San Juan 30-5 Unit

8. Well No. 230A

SUNDRY NOTICES AND REPORTS ON WELLS

ConocoPhillips requests a change to our BOP test submitted on the APD. Attached is the BOP program for the 9-5/8" and 7" casing.

For Cavitation Program

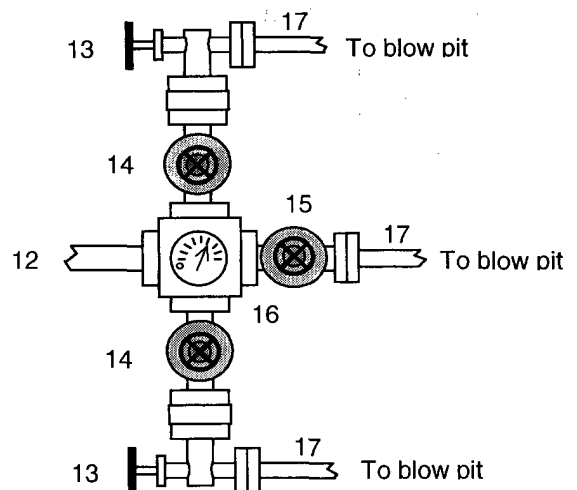
This BOP arrangement and test program is for the cavitation program. The BOP will be installed on the tubing head. The 7" casing will be pressure tested against closed blind rams to 200 psi to 300 psi for 2-3 minutes and to 1800 psi for 30 minutes - this test pressure is 48% of the minimum internal yield strength of 3740 psi for the 7", 20#, J-55, STC casing. The pipe rams and choke manifold will be tested to 200 psi to 300 psi (low pressure test) for 2-3 minutes and to 1800 psi (high pressure test) for 10 minutes - This test will be done with a test plug or possibly without a test plug (ie against casing). If we conduct this test without a test plug we will ensure that we have sufficient drillstring weight in the hole to exceed the upward force generated by the test.

We use a power swivel and air/mist to drill the 6-1/4" hole in our cavitation program. We do not use a kelly. In addition to the equipment in the above diagram the following equipment will comprise the BOP system:

1. String floats will be used inside the drillpipe
2. Stab-in TIW valve for all drillstrings in use
3. Each blooie line is equipped with a hydraulically controlled valve (HCR valve).

For Drilling to Intermediate Casing Point & Setting 7" Intermediate Casing

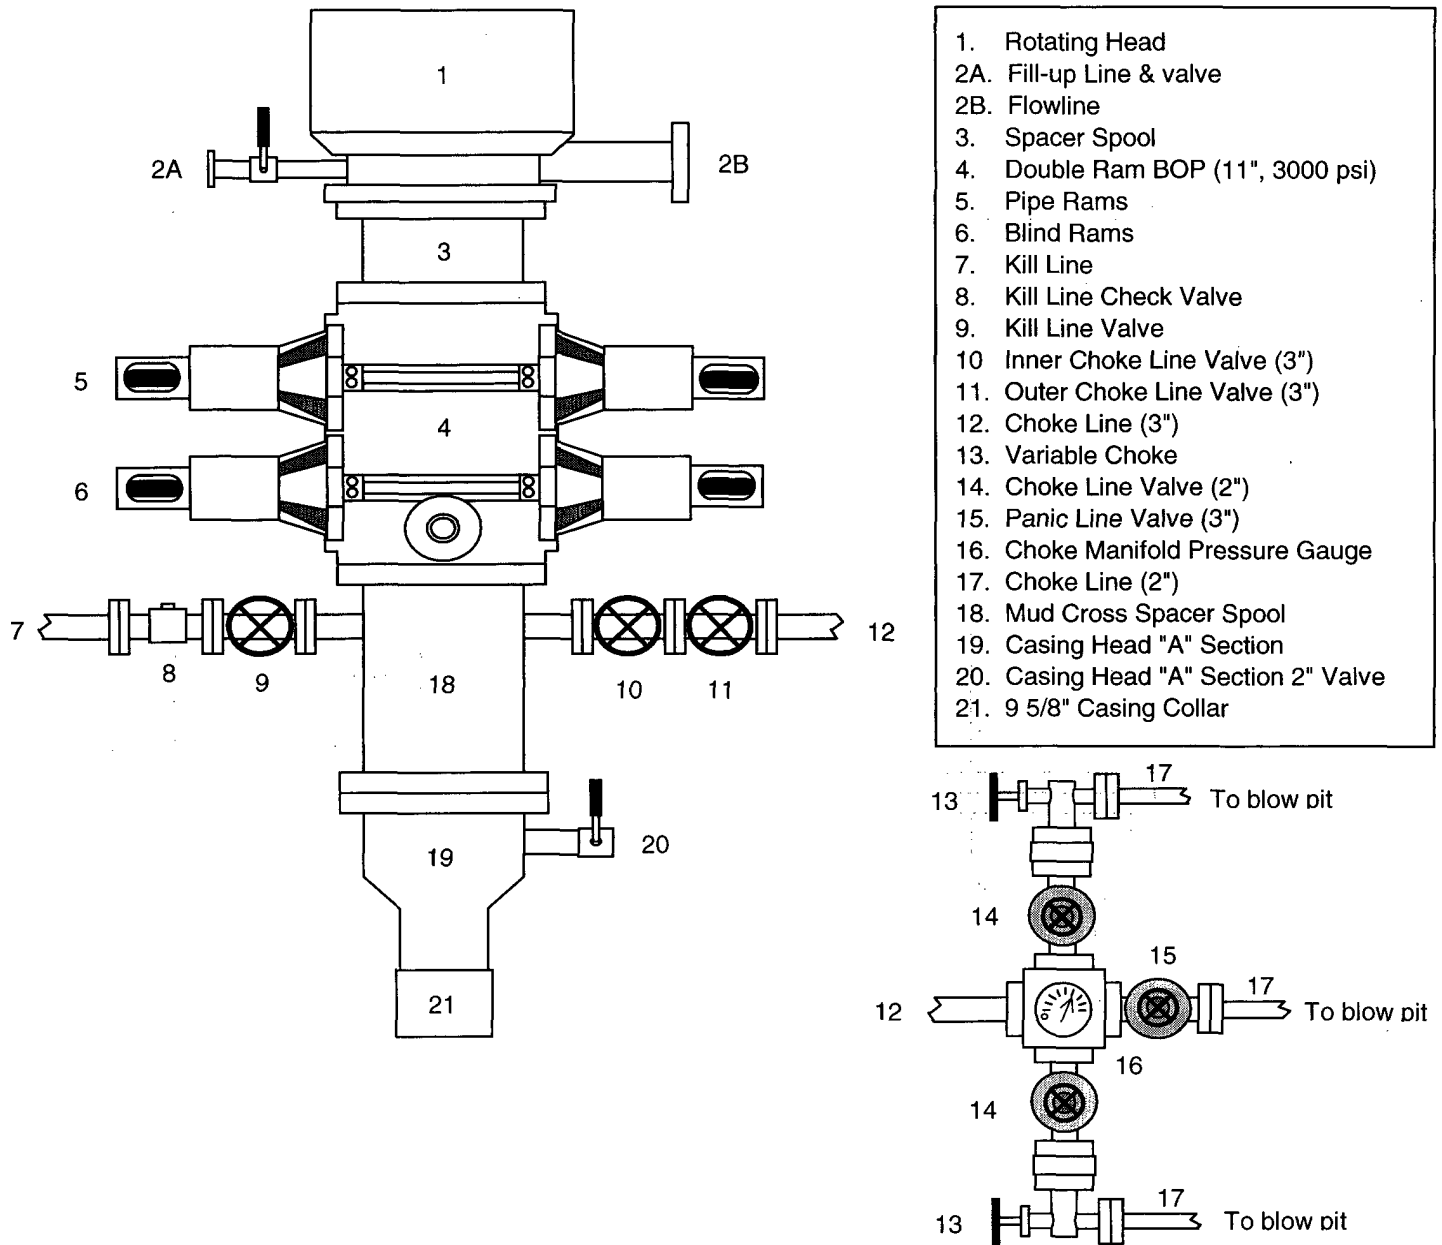
A 12-1/4" hole will be drilled to approximately 220' and the 9-5/8" surface casing will be run and cemented. The Casing Head "A" Section will be screwed onto the 9-5/8" surface casing stub. The BOP will be installed on the Casing Head "A" Section. A test plug will be set in the wellhead and the pipe rams and choke manifold will be tested to 200 psi to 300 psi (low pressure test) for 2-3 minutes and to 1000 psi (high pressure test) for 10 minutes. Then the test plug will be removed, and the **9-5/8" casing will be pressure tested** against closed blind rams to 200 psi to 300 psi for 2-3 minutes and **to 1000 psi for 30 minutes** (this value is one 44% of the minimum internal yield pressure of the 9-5/8" casing). (Note: per regulatory requirements we will wait on cement at least 8 hrs after placement before testing the 9-5/8" surface casing). Then an 8-3/4" hole will be drilled to intermediate casing point and 7" intermediate casing will be run and cemented.

In addition to the equipment in the above diagram the following equipment will comprise the BOP system:

1. Upper Kelly cock Valve with handle
2. Stab-in TIW valve for all drillstrings in use
